**Re: The Missouri Manufactured Housing Association's Comments on the following proposed rules and amendments to rules concerning modular units and manufactured homes: 4 CSR 240-123.040, 4 CSR 240-123.065, 4 CSR 240-123.070, 4 CSR 240-123.080, and 4 CSR 240-124.040.**

The Missouri Manufactured Housing Association has the following comments concerning the above-referenced proposed rules and amendments to rules.

**TABLE (E)**  
**CRISS-CROSS STRAPPING SYSTEM**  
 For elevated multi-section homes  
 (or portions thereof)  
 to be used in lieu of Diagonal Tie down Strap  
 Spacing Table

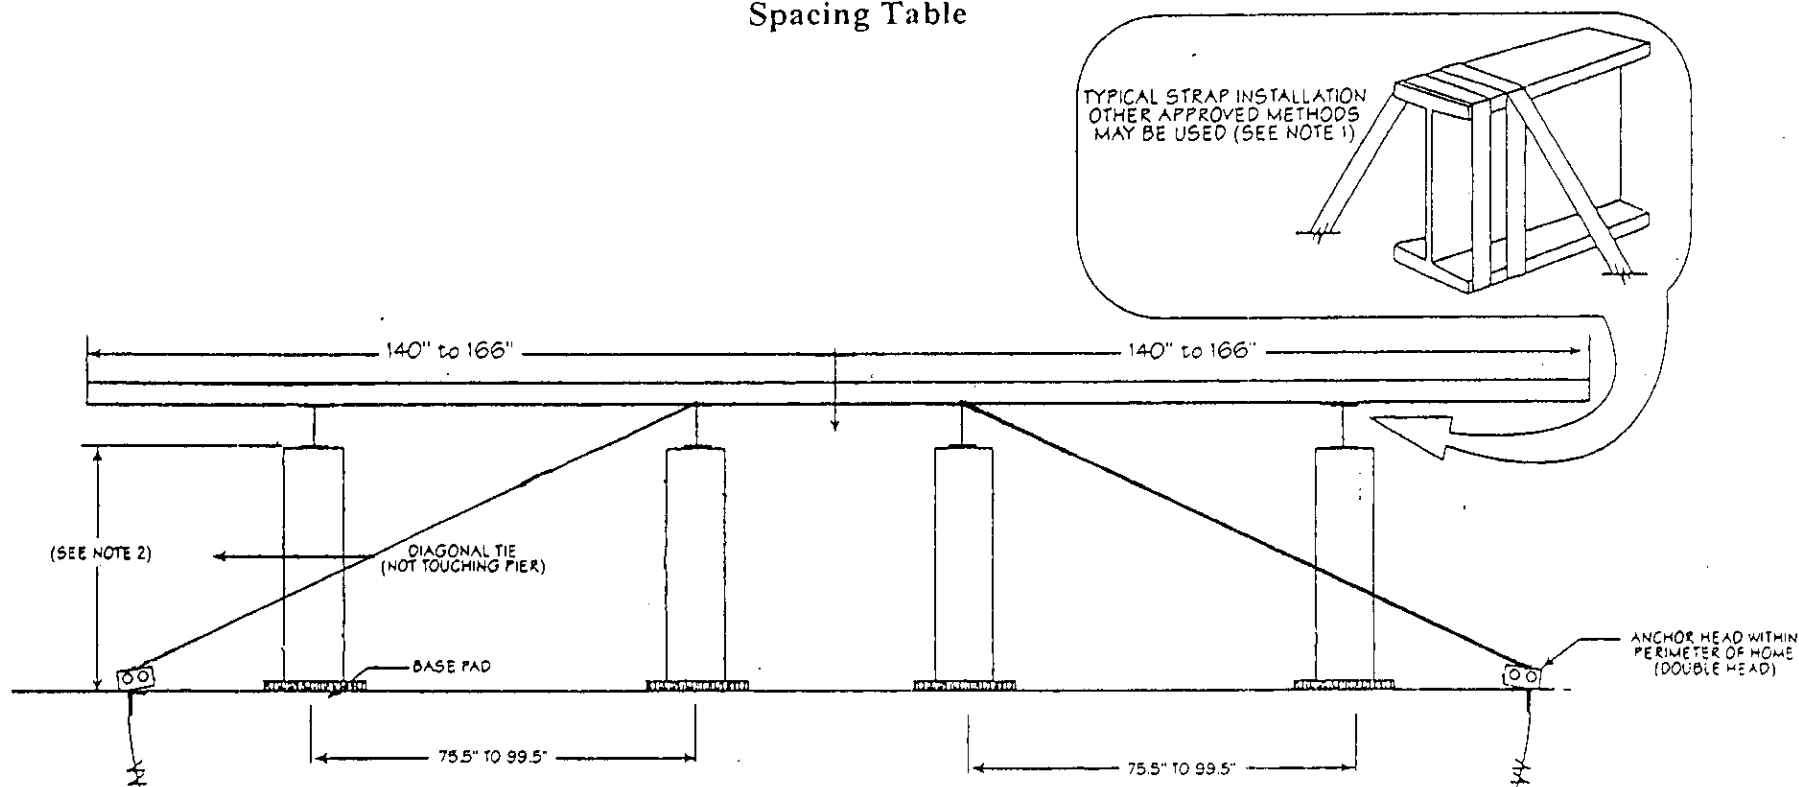
13. Table (E) - The Association proposes to reword the heading of Table E. To make the table more descriptive of its purpose the Association proposes to reword the heading as follows: **Table E strapping system for use in lieu of Diagonal Tie down Strap Spacing Table in circumstances where 40° to 50° anchor angle can not be achieved.**

The Association also proposes to revise the Table E Table (see attached drawing). On the attached drawing, moving from left to right, the piers are numbered 1, 2, 3 and 4 and the anchors are identified as anchor A and B. As per the advice of engineers employed by the Association the strap going from anchor A to pier 4 would be eliminated and replaced by a strap going from anchor A to pier 2. Similarly the strap going from anchor B to pier 1 would be eliminated to be replaced by a strap going from anchor B to pier 3. The straps from anchor A to pier, 1 and from anchor B to pier 4 would also eliminated. In the opinion of the Association's engineers this method of strapping is preferable to the criss-cross strapping system shown in the drawing portion of proposed Exhibit E. Since the Association's proposed drawing eliminates cross strapping, the Association suggests that the words "criss-cross" be deleted from the heading.
